Item Name: Crosstube Turning Detail

D407-667-145	Rev C
--------------	-------

DRAWING NO. D407-667-145	TITLE CROSSTUBE ASS'Y (407 HIGH FWD)	REV. C	DART AEROSPACE LTD ENGINEERING ORDER		D.E.O. NO. D407-667-145-C-1	SHEET NO. SHEET 1 OF 1	SCALE NTS
DRAWN 40	CHECKED ASS	MFG. APPR. 128	APPROVED [Signature]		DE APPR. [Signature]		
DATE 11.07.15	DATE 11.07.22	DATE 11.07.22	DATE 11/07/22		DATE 11.07.21

DRAWING NO. D407-667-145	TITLE CROSSTUBE ASS'Y (407 HIGH FWD)	REV. C	DART AEROSPACE LTD ENGINEERING ORDER	D.E.O. NO. D407-667-145-C-2	SHEET NO. SHEET 1 OF 1	SCALE NTS
DRAWN AJS	CHECKED [Signature]	MFG. APPR. [Signature]	APPROVED [Signature]	DE APPR. [Signature]		
DATE 12.08.02	DATE 12.08.02	DATE 12.08.02	DATE 12.08.02	DATE 12.08.02

**DETAIL P**
BONDING STRAP INSTALLATION 2 PL

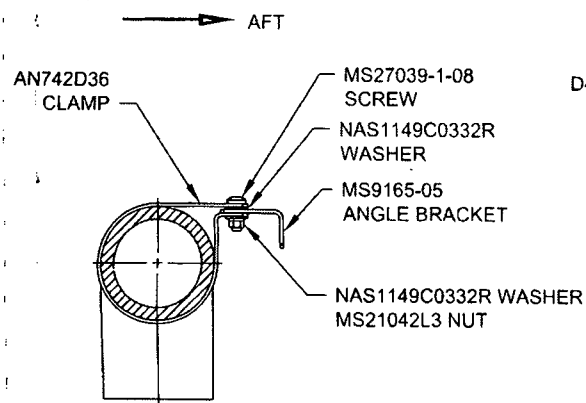
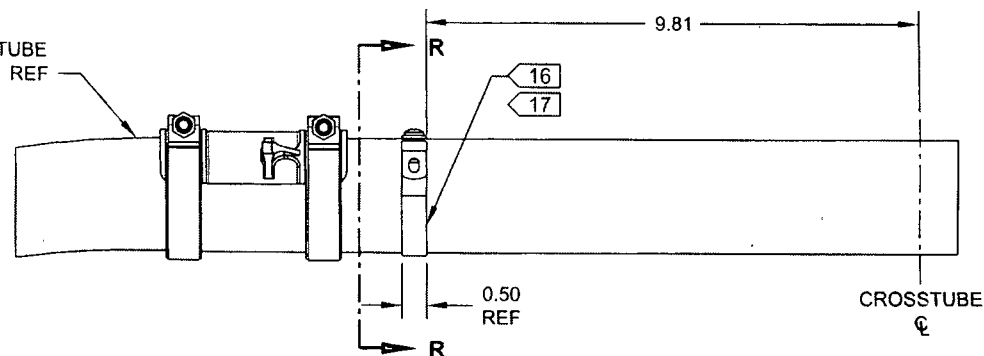
PURPOSE:

ADD ELECTRICAL GROUNDING STRAP

ITEM	QTY -145	PART NUMBER	DESCRIPTION
1	X	D407-667-145	CROSSTUBE ASSEMBLY (407 HIGH FWD)
10	2	AN742D36	CLAMP
11	2	MS9165-05	ANGLE BRACKET
12	2	MS21042L3	NUT (OR MS21042-3)
13	2	MS27039-1-08	SCREW
14	4	NAS1149C0332R	WASHER (OR AN960C10L)

- 16) MASK AREA UNDER CLAMP PRIOR TO PAINTING
 17) SEAL EDGES WHERE AN742D36 CLAMP MEETS WITH THE CROSSTUBE USING SIKAFLEX-241/-291 OR MIL-S-8802 CLASS B2 OR PROSEAL 890 SEALANT
 18) PERFORM RESISTANCE CHECK TO ENSURE MAX RESISTANCE IS 10 MILLIOHMS
